**Development Application: 191-195, 197-199 and 201 Oxford Street,
Darlinghurst - D/2022/327**

File No.: D/2022/327

The application is recommended for refusal as it, amongst other matters, fails to deliver a design that is consistent with the design criteria for the newly created Oxford Street Cultural and Creative Precinct (Precinct).

Figure 12: Development proposal outlined in the Urban Design Submission (source: NEESON MURCUTT + NEILLE)

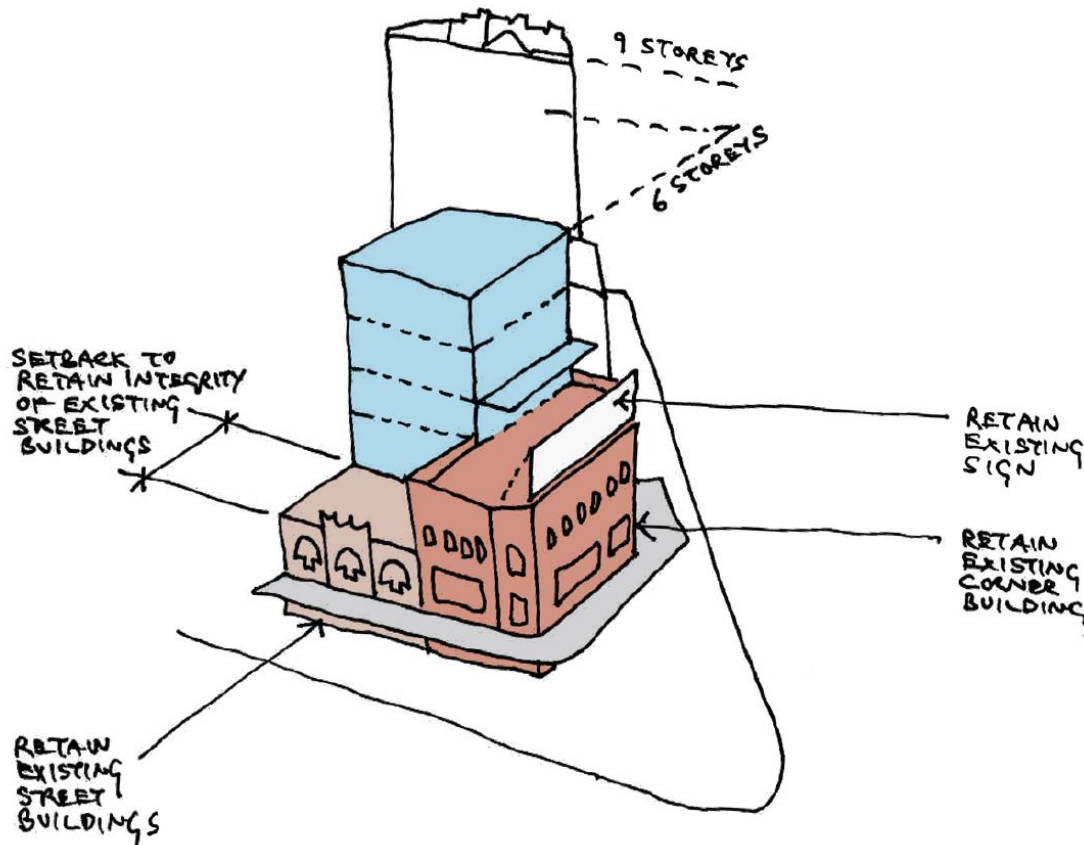
26. The development proposal outlined in the submission is substantially the same as the subject application, and the sketch illustrating that proposal is reproduced in Figure 12 below.

"The proposal creates excessive bulk behind the corner buildings and does not sufficiently engage with the street corner and define Taylor Square. The increased setback to Oxford Street is not warranted and will create a missing tooth on the new, recessed, upper street wall that is intended by the draft planning controls.

Figure 5.273
Additions are
to reflect the
individually
distinctive massing
on Oxford Street
5.11.5.2(1)

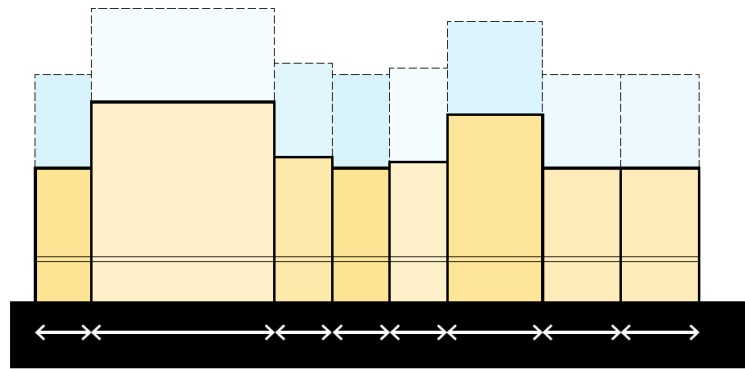
- (c) The vertical addition is to reflect the existing pattern of stepped heights and vertical articulation to reflect the original phase of development of Oxford Street, as shown in Figure 5.273 of the DCP, reproduced below:

Figure 32: Height exceedance shown on a section through 197 Oxford Street - the maximum 12m height plane is shown in red, and the alternative 20m height plane is shown in light green

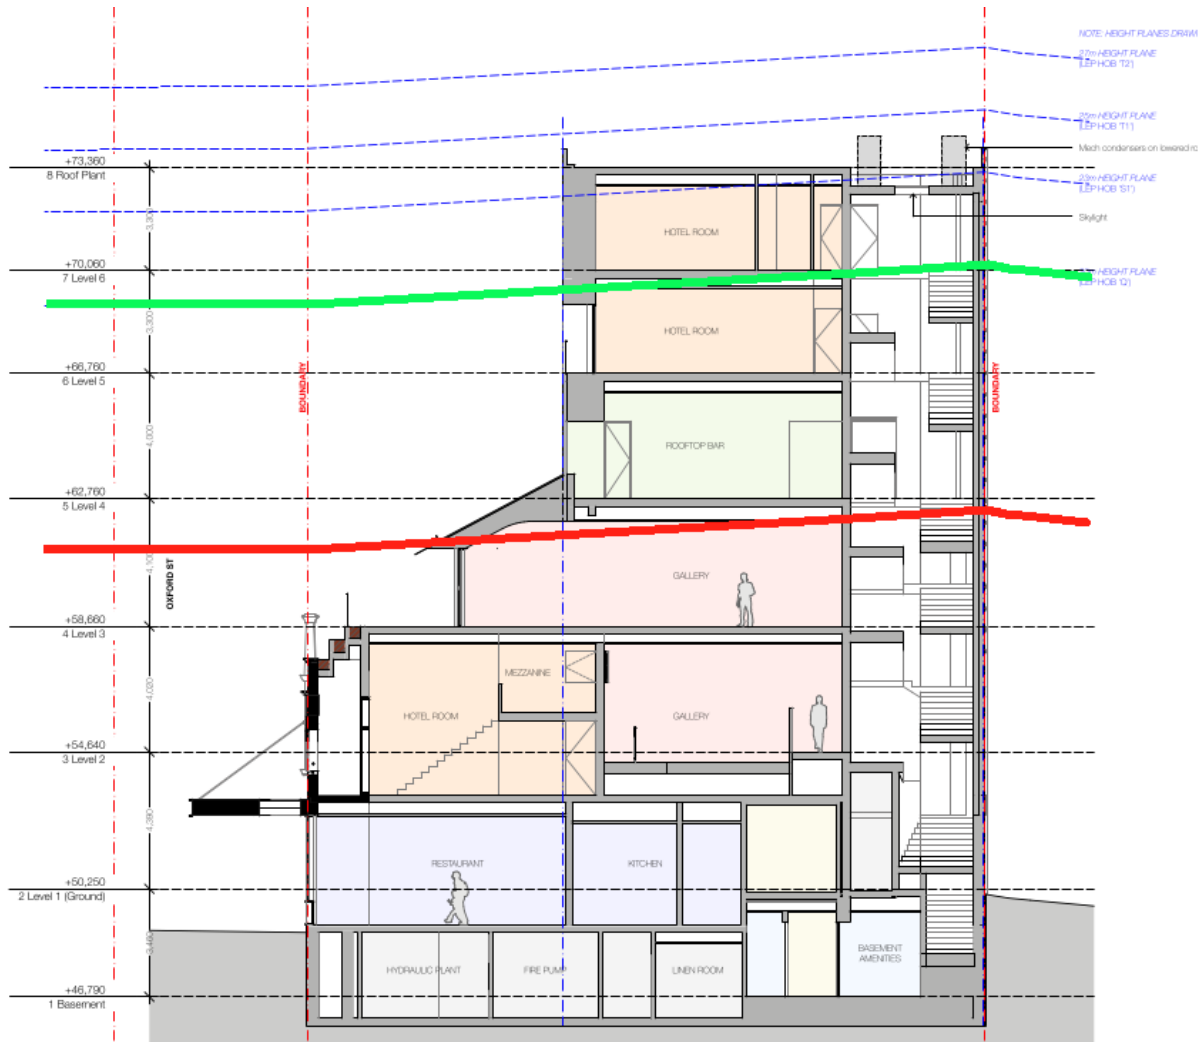
- (a) The proposed development is six storeys in height (24.8m), exceeding the maximum five storey height control and the alternative maximum height of 20m. The additional FSR sought under clause 6.60D of the LEP is also not wholly contained within the identified maximum height.
- (b) The six storey height and the lack of vertical addition to the corner building at 191-195 Oxford Street, fails to respect the existing pattern of stepped heights. The resultant building heights will step up from the corner building instead of stepping down towards the east along Oxford Street as shown in Figure 30.
- (c) The lack of vertical addition at 191-195 Oxford Street also misses the critical opportunity to provide a strong visual and physical edge to Taylor Square.

63. The area above the maximum 12m height plane, denoted by a red line, is identified in the section in Figure 32 below. The alternative 20m height plane is denoted in light green for reference.
